P-17736-1

E0781

ISSUE-2

NAME	DATE
DRAWN		J.P.KAUSHIK	22-01-2018
CHECKED			
APPROVED		B.NATARAJA	29-01-2018
SCALE			1:1
AREA mm^2			1788.632
PERIMETER mm.			525.53
WEIGHT kg/m			4.829
PARTY'S NAME	RAM RATNA ELECTRICALS LTD., HARIDWAR		
PARTY'S DRAWING No.	AS PER DRAWING & REQUIREMENT		
ALLOY & TEMPER	6063 T6		
DESCRIPTION	LOUVER BLADE SECTION

DRAWING No.	SECTION No.
P-17736-1	–
E0781	E0781(ISSUE-2)

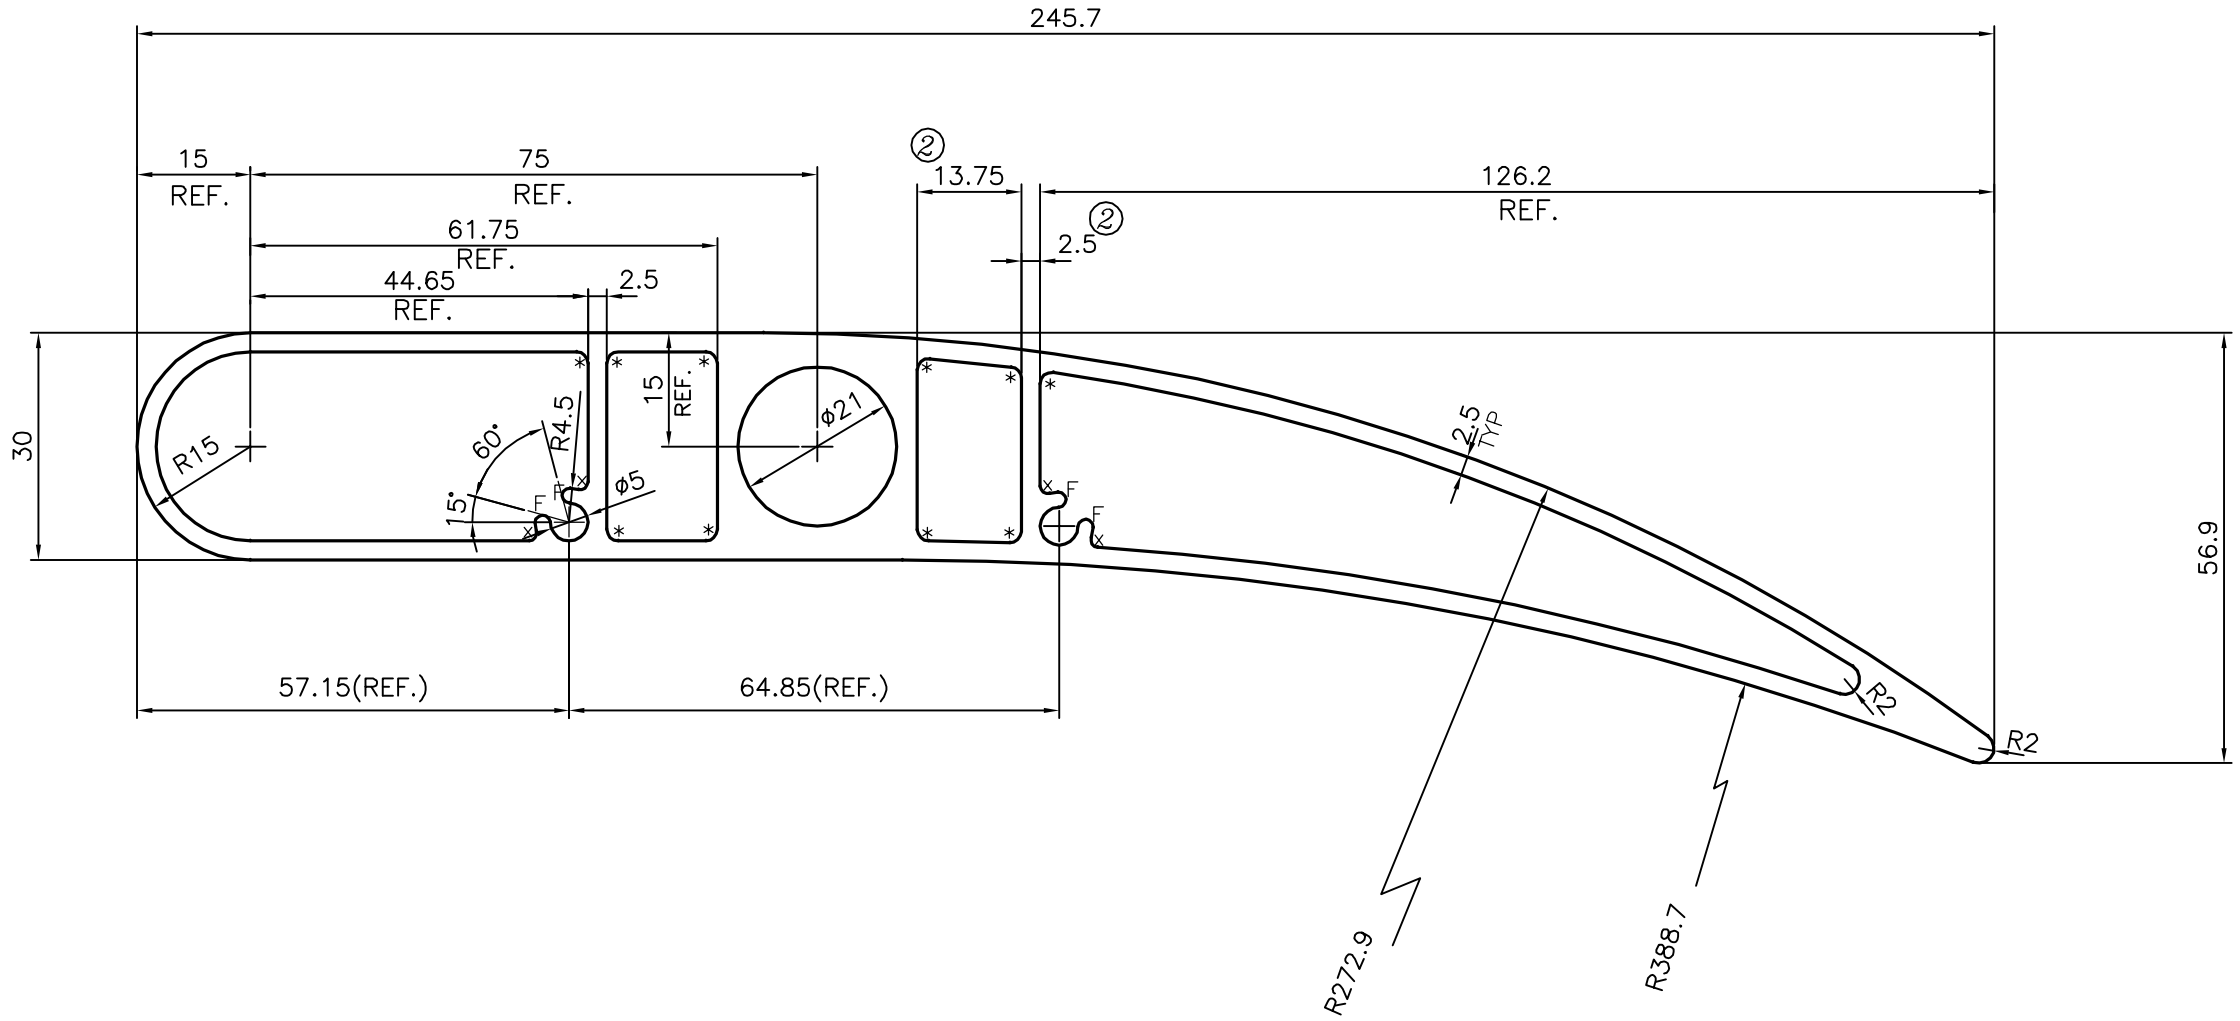
THICKNESS CHANGED FROM 4.0 mm TO 2.5 mm DIMENSION CHANGED FROM 12.25 mm TO 13.75 mm,

(THIS MODIFICATION AS PER PARTY REQUIREMENT AS E MAIL ON DATED (22/01/2018)

WEIGHT ALSO CHANGED FROM 4.923 TO 4.829 kg/m
